APPENDIX E CASE 10-T-0139 JUSTIFICATION FOR DEVIATION ZONE EXCURSIONS ASSOCIATED WITH SEGMENT 9

2.0 EXPLANATION FOR PROPOSED EXCURSIONS FROM THE DEVIATION ZONE IN SEGMENT 9

Table 1-1. Deviation Zone Excursions in Segment 9

Appendix E. Segment 9 Alignment Excursions

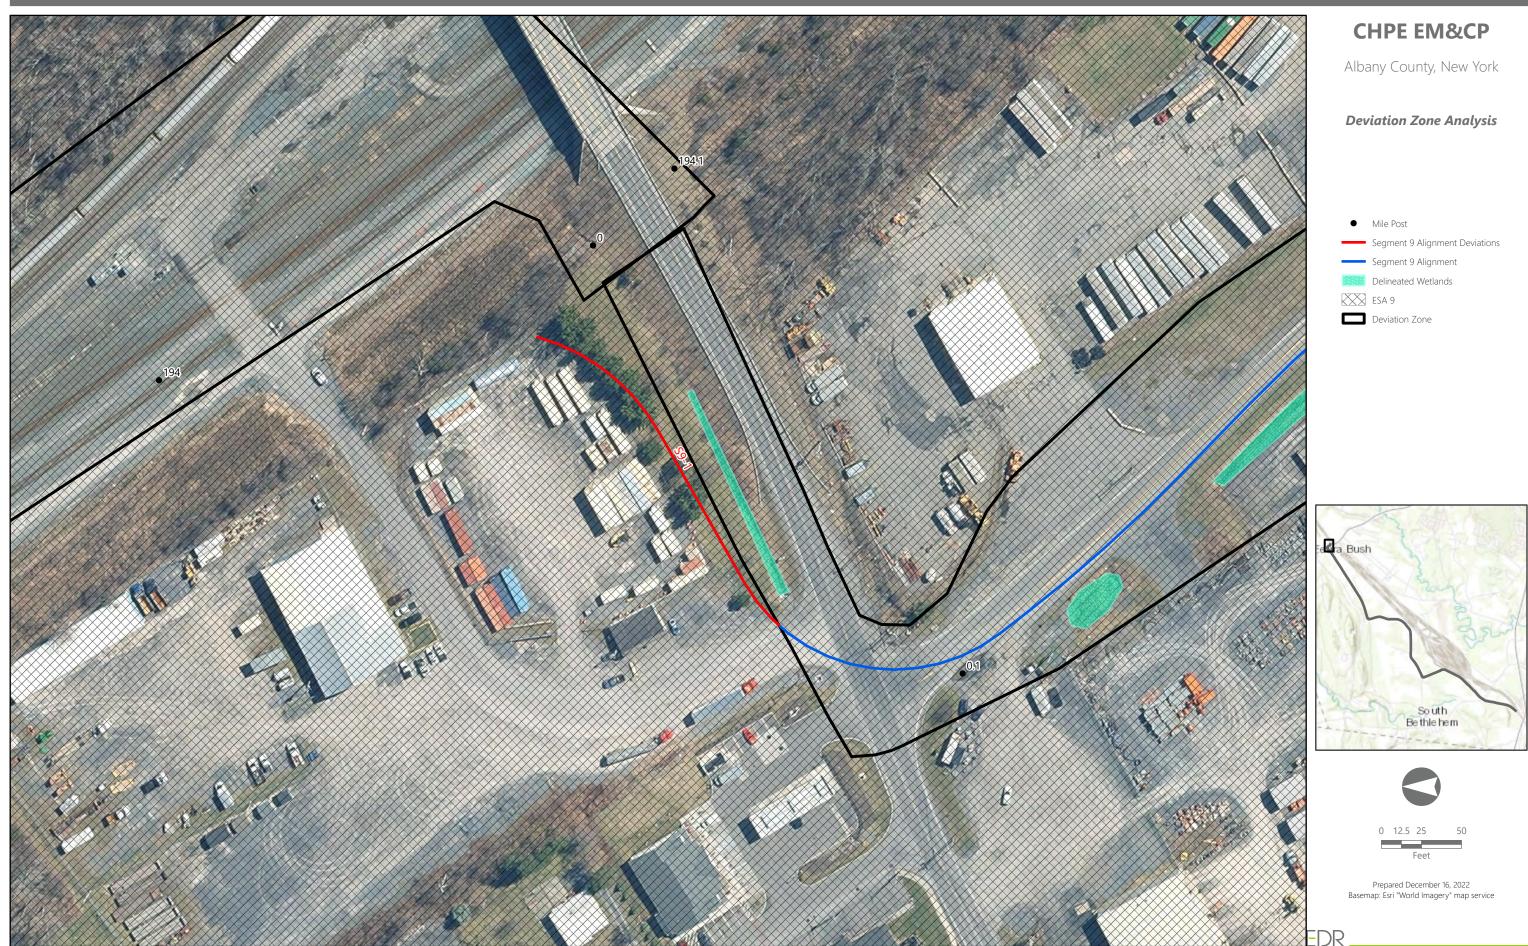
| Deviation Zone Excursion | Parcel | Sheet | Approximate (see drawings for more detail) | | Justification for Revision | Environmental Impact |
|--------------------------------|------------------------|-------|-----------------------------------------------|-------------------|----------------------------------------------------------|-------------------------|
| S9-1 | NA – within CSX ROW | C-101 | 51000+00 | 51003+00 | Avoiding road embankment and wetland | See below |
| S9-2 | 132.00-2-26 | C-114 | 51197+00 | 51200+00 | Additional space required for splice location #191 | See below |

Segment 9 Excursion 1 (Excursion S9-1) is located parallel to the Indian Fields Road crossing (approximately STA 5100 to 51003 on Sheet C-101 of the Plan and Profile Drawings (Appendix C of the EM&CP); see also attached figure set).

At this location, there is a steep embankment beginning at the edge of the road that limits construction, access and trench installation. In order to avoid this steep slope, and a delineated wetland at the base of the embankment, the alignment will be placed outside of, and parallel to, the ADZ for a total of approximately 300 linear feet. This ADZ Excursion request is grounded in both environmental and engineering reasons and is the minimum necessary to feasibly achieve the installation without impacting a wetland and steep slope.

Excursion S9-2 is located within the Town of New Scotland beginning at the edge of the CSX ROW (approximately STA 51197 to 51200 on Sheet C-114 of the Plan and Profile Drawings (Appendix C of the EM&CP); see also attached figure set).

Splice vault locations are required at a certain interval (at least every 3,200 feet, approximately) to correspond to the length of cable on each reel. At Excursion S9-2 additional space is required for Splice 191. The splice work area must be placed perpendicular to the alignment and therefore there is not enough space for the splice work area between the tracks and the alignment at this location. Due to this spatial requirement, the alignment leading up to and out of the splice, and the splice itself will be placed outside and parallel to the ADZ. for approximately 83 linear feet. This ADZ Excursion request is grounded in engineering reasons and is the minimum necessary to feasibly achieve the installation.
